**Twin Pines Permit Coordination Document**  
**Charlton County: Saunders Demonstration Mine**  
**April 14, 2021**

1. **Surface Mining Application and Mining Land Use Plan Review Comments by Surface Mining Unit (Contains most MLUP sheets)**
  - a. Please add Mine ID No. 2073 to each sheet or Figure.

4. **Provisions Check List and Explanations for Protection of the Environment and Resources of the State Comments by: Surface Mining Unit**

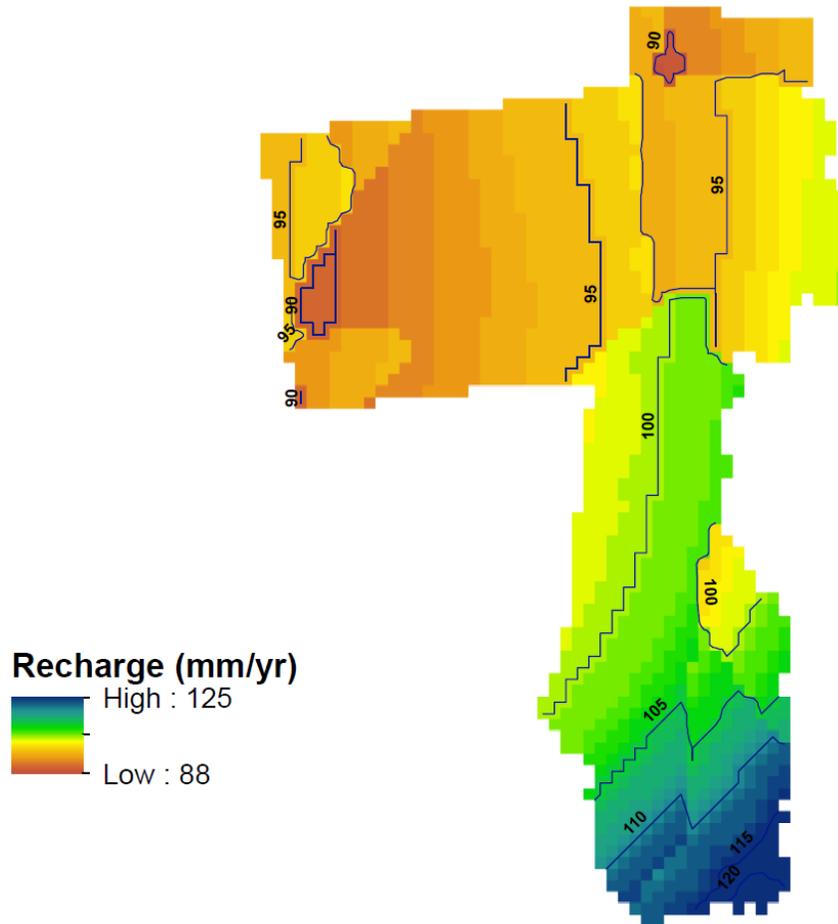
- a. Explanations
  - i. Please note that the Surface Mining Rules Section 391-3-3-.05(1) requests that the Mining Land Use Plan include provisions for protection of the environment and resources of the State. The checklist that was provided to Twin Pines, was taken from GEPA but meant to be used as a guidance for Twin Pines to follow and make their own. EPD is not asking Twin Pines to follow GEPA regulations. The provisions checklist will be an addendum to the Surface Mining Land Use Plan (MLUP) and used during public meetings as an outline of the affects the Twin Pines project may have on the surrounding environment and resources of the State.

- ii. Wetlands- Give a brief description of how the non-jurisdictional wetlands will be temporarily affected and then reclaimed.
  - iii. Flood Plain/River Corridor- Cite the source that was used to determine the claim.

- iv. Water Supply- State how the proposed withdrawal is compared to the production capacity of the Floridan Aquifer. Also provide the distance to the nearest known supply well, public or private, completed in the Floridan Aquifer. Will withdrawal from the Floridan Aquifer create a cone of depression that may impact nearby watersheds? If so, this data needs to be provided or pointed to within the MLUP.

- v. Water Resources- Please provide an explanation of any potential water quality impacts as a result of the groundwater withdrawal from the Upper Floridan Aquifer.

- vi. Groundwater Recharge- No comment.
  - vii. Stormwater- Please state the name of the receiving stream from the discharge. Provide details of a contingency plan if discharge is greater than pre-mining conditions. Briefly describe erosion/sediment controls at discharge location(s).

- viii. Wastewater- Briefly state how the water will be treated and how the effluent will be monitored for permit compliance.
  - ix. Air Quality- Briefly describe how Twin Pines will minimize particulate/opacity emissions. This area is for the mine boundary as well as the plant.

- x. Solid Wastes- The first sentence indicates that process solid waste may be generated but will stay on-site; please clarify what Twin Pines will do with processed solid waste. Second sentence- Please state how the office-related waste will be properly transported and disposed. Can you describe how the land clearing will be handled?

- xi. Soil/Stability/Erodibility- Please describe how the site will reduce the potential for sediment-laden soils to leave the site. Briefly describe the berm during mining activities and the deposition of the berm following reclamation.

- xii. Protected Mountains- No comment.
- xiii. Protected Species- Briefly describe what protected species may be/are present in the area, what surveys were conducted, and if any protected species were found in the proposed mine footprint. Include some of the information that you provided in Exhibit D.

- xiv. Critical Habitats- Rephrase to include that the nearest critical habitat identified is the Okefenokee NWR and it's 2.9 miles away.
- xv. Historical- Please refer to the Cultural Resources assessment as Exhibit C of the Surface Mining Land Use Plan.

- xvi. Archaeological- Please state if there are any known historical/cultural/archaeological resources on the mine property or on the adjacent properties. Please explain what procedures will be followed if these resources are found while mining.

- xvii. Parks/Recreation- Please explain "negligible" affects. If there is going to be an affect, please provide a brief explanation and cite applicable sources.

- xviii. Energy Supplies- Please state who will run the necessary power lines to supply the operation and state whether the power draw will affect surrounding businesses and/or homeowners or not. If an affect is expected, explain what the affect will be. Please include average projected energy use to verify statement (equivalent to an average household power usage).

- xix. Beaches- No Comment
- xx. Dunes- No Comment
- xxi. Shoreline- No Comment
- xxii. Coastal Marshland- No Comment
- xxiii. Forest Land- Please provide more information on what types of trees will be planted during reclamation.

- xxiv. Barrier Island- No Comment
- xxv. Aquatic Life/Trout Streams- Please state that the NPDES discharge limits are designed to be protective of aquatic life and describe how the sampling will ensure water discharge permit compliance.
